SERVICE BULLETIN

B-060

SAFETY RECALL CODE 0830 - SIDESTAND PIVOT BOLT FOR 2005 FIREBOLT XB12R AND LIGHTNING XB12S, XB9SX

Figure 1. Correct Pivot Bolt with Springplate Pin

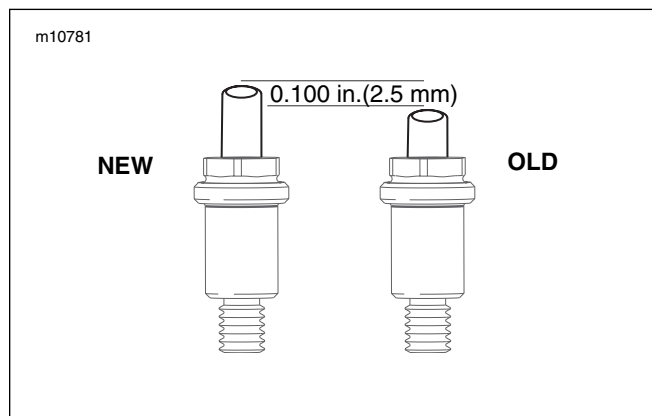
See Figure 1. Correcting the potential safety defect requires replacement of the sidestand pivot bolt, Part No. L0174.1AA. The replacement pivot bolt, Part No. L0174.1AAB, is 0.100 in. (2.5 mm) longer in the spring plate pin area and has a gold hue plating. **The recall kit Part No. is 94394Y.**

Figure 2. Sidestand Assembly

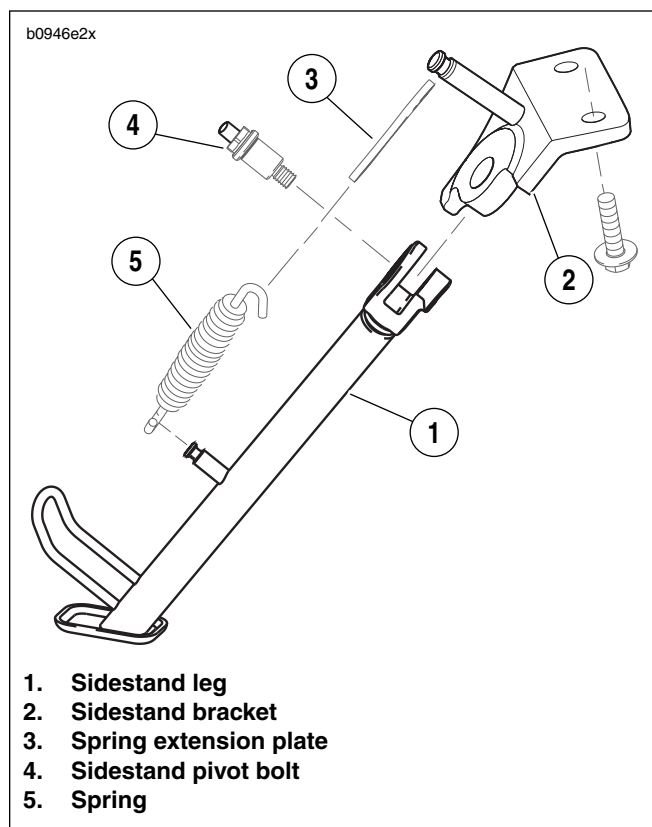
1. Remove two fasteners from left side of chin fairing.
2. See Figure 2. Remove sidestand pivot bolt (4).
 - a. Retract sidestand leg.
 - b. Remove sidestand spring (5) and spring extension plate (3) using SNAP-ON SPRING TOOL (Part No. HE-52B).
 - c. Remove sidestand pivot bolt (4).

- c. See Figure 2. Install sidestand pivot bolt (4) tightening to 18-20 ft-lbs (24-27 Nm).
 - d. Retract sidestand leg.
 - e. Install spring extension plate (3) and sidestand spring (5) using SNAP-ON SPRING TOOL (Part No. HE-52B).
2. Apply LOCTITE 272 (Red) and install the two left side chin fairing fasteners and tighten to 36-48 in. lbs (Nm).

Figure 3. Lubricating Points (Shaded Areas)

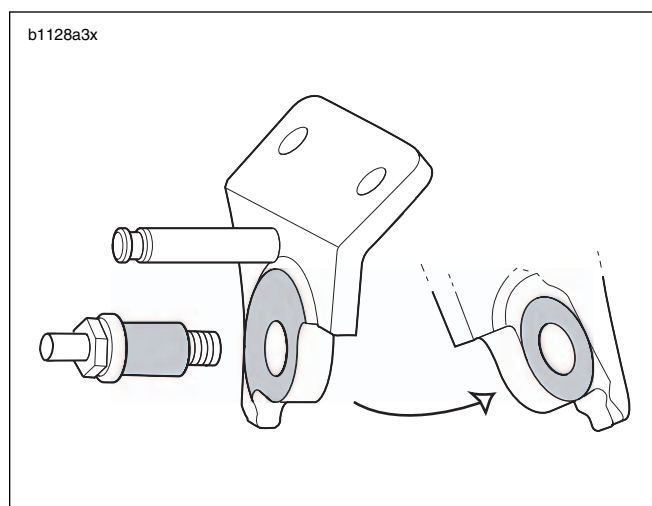
1. Install **new** longer sidestand pivot bolt (4).
 - a. See Figure 3. Lubricate sidestand pivot bolt and mating portions on sidestand bracket with WHEEL BEARING GREASE (Part No. 99855-89) on shaded areas only.
 - b. See Figure 4. Apply LOCTITE 272 (Red) to threaded area (clevis) of sidestand leg.

Figure 4. Threaded Area for Loctite Application

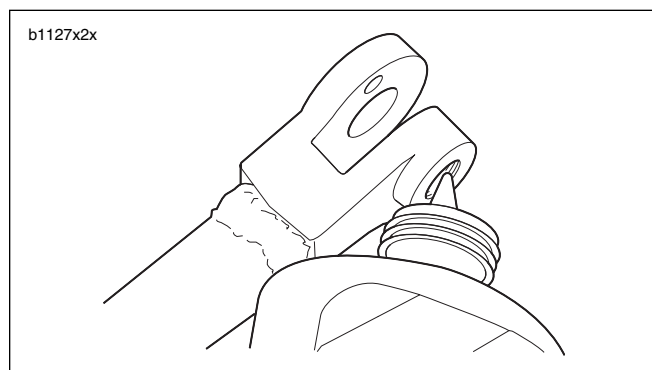
Applying LOCTITE to threaded area of clevis on sidestand leg, instead of threads on the pivot bolt, will eliminate build-up between clevis and sidestand bracket which can interfere with the applied lubricant.
